ADDENDUM NO. 01**DATE: April 22, 2020****PROJECT: Inglemoor High School Concert Hall + Music Building Project**

1. Addendum NO. 1 from Hutteball + Oremus Architecture dated April 21, 2020 is attached to this addendum.

PROJECT: Inglemoor High School Concert Hall + Music Building Project

SHEET A3.40 – Wall Types & Assemblies

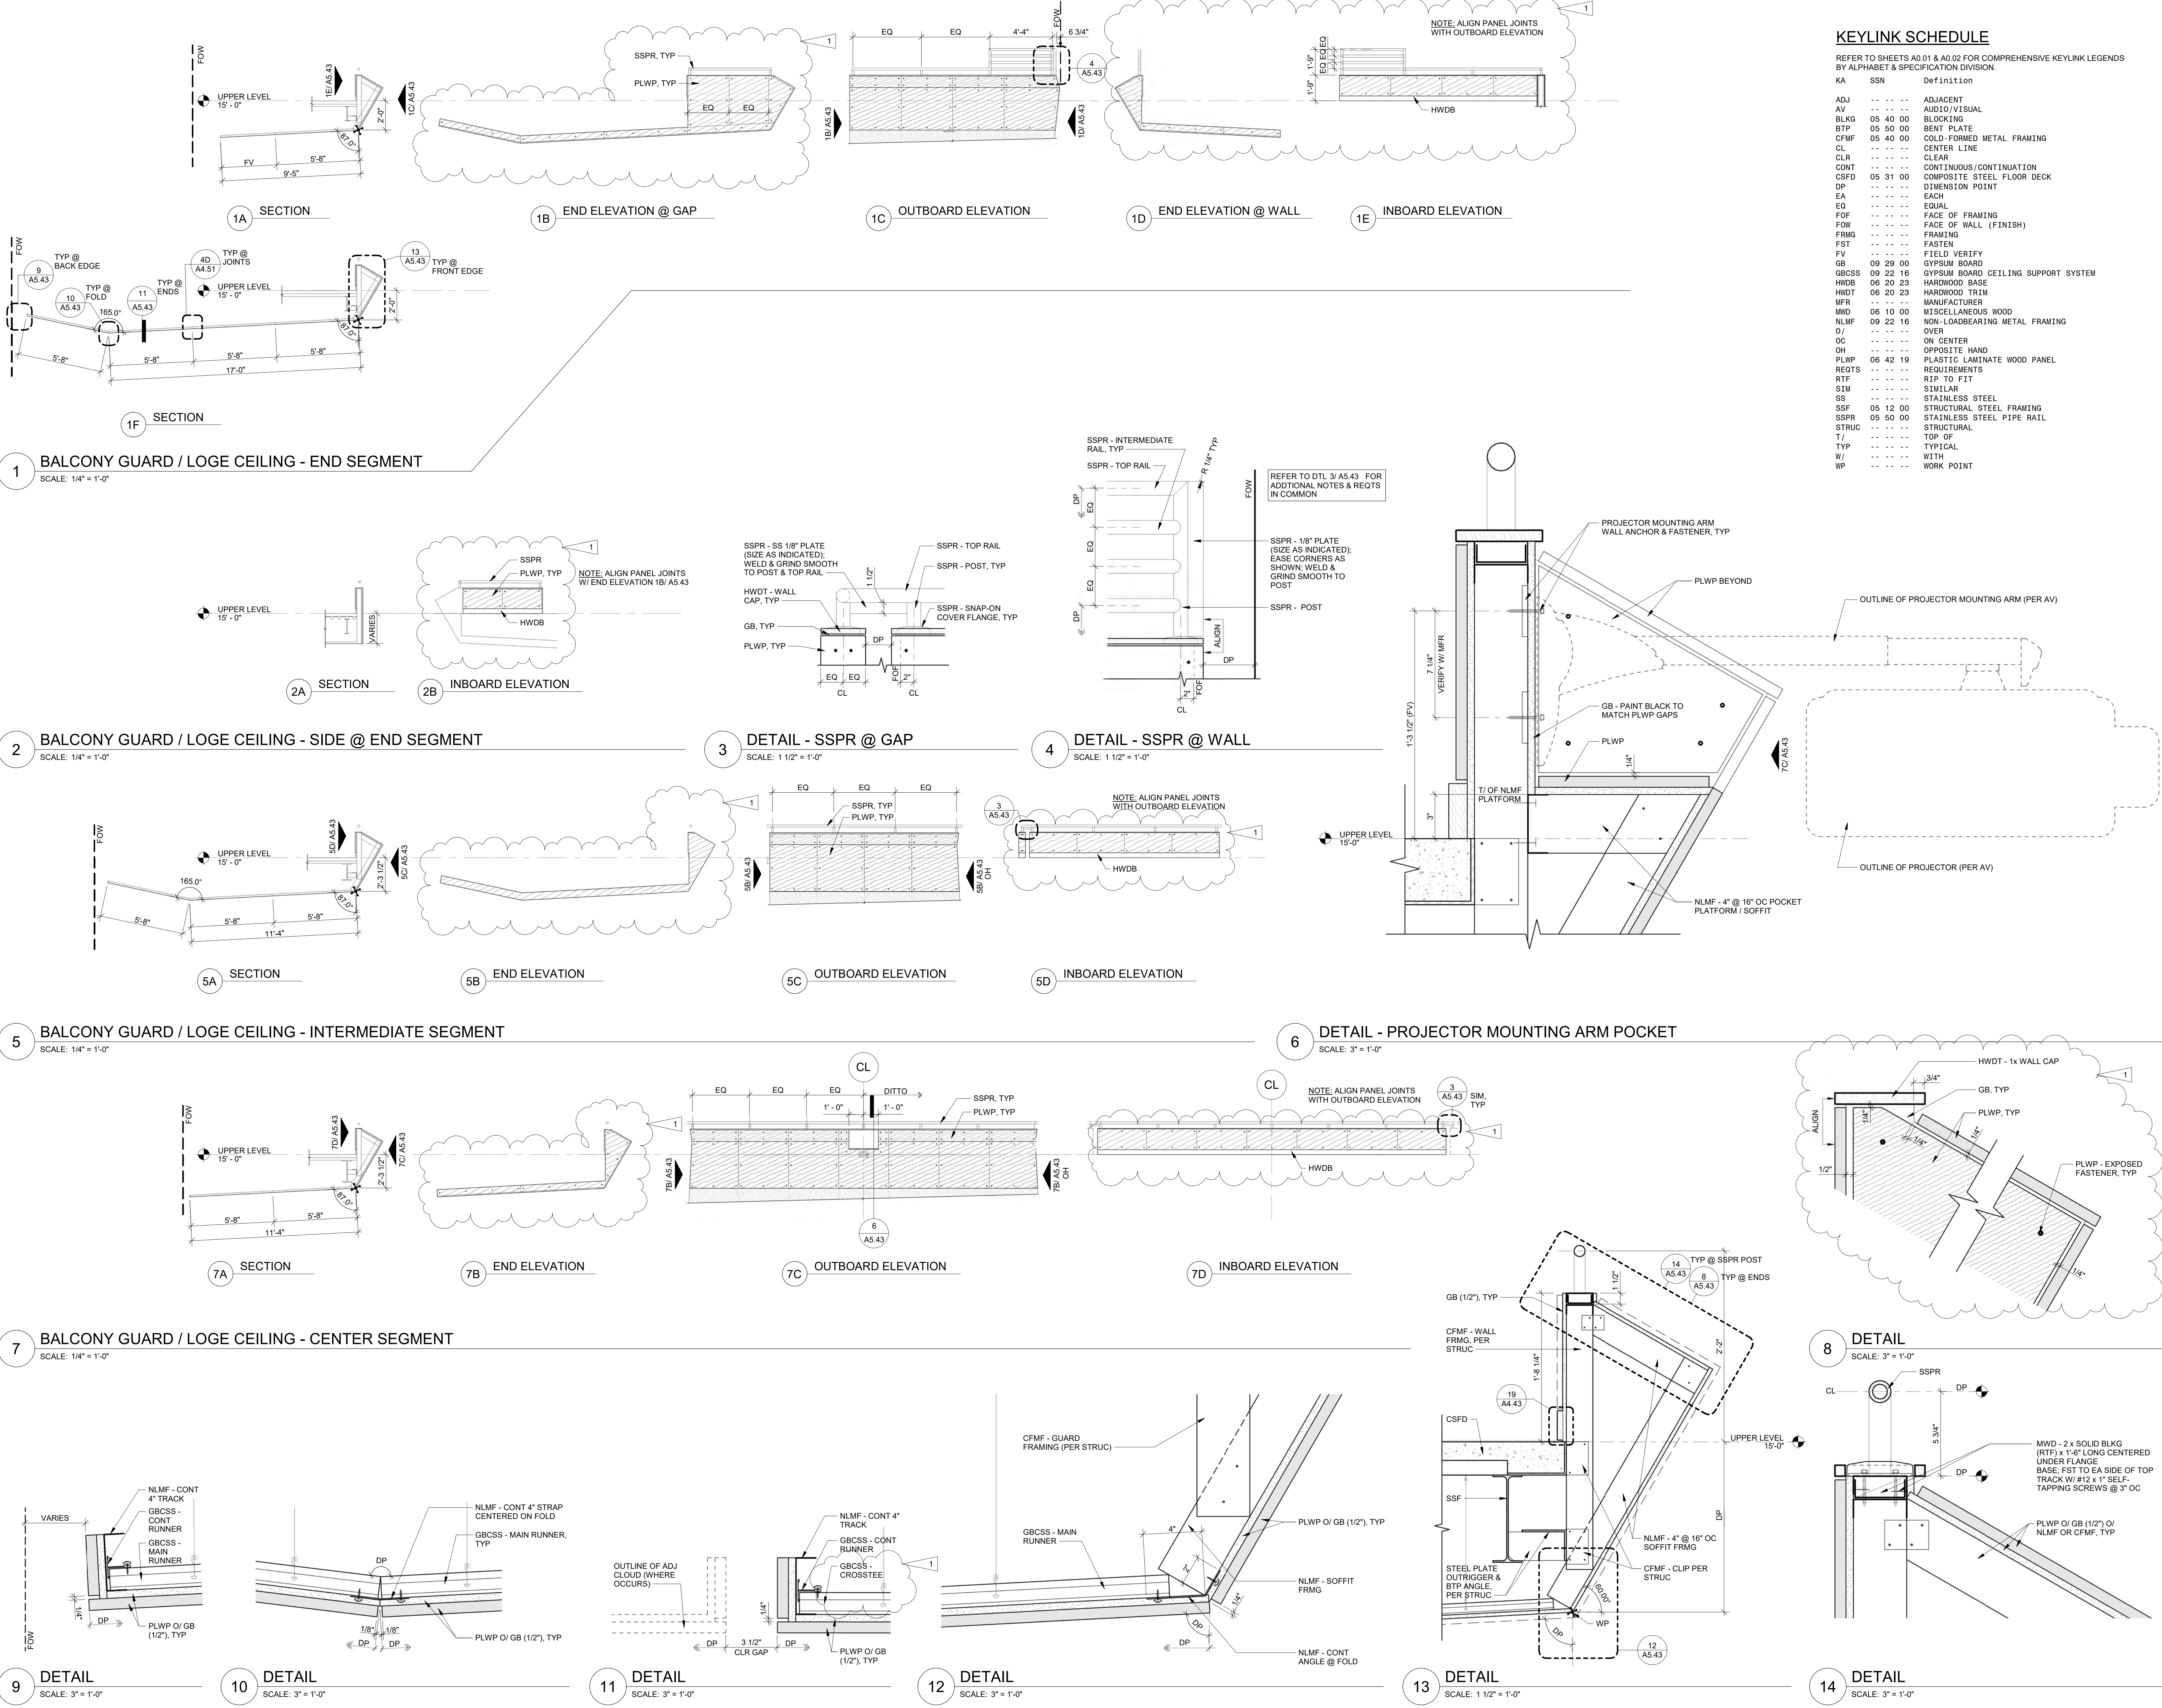
1. On Detail 17, REVISE per attachment A3.40
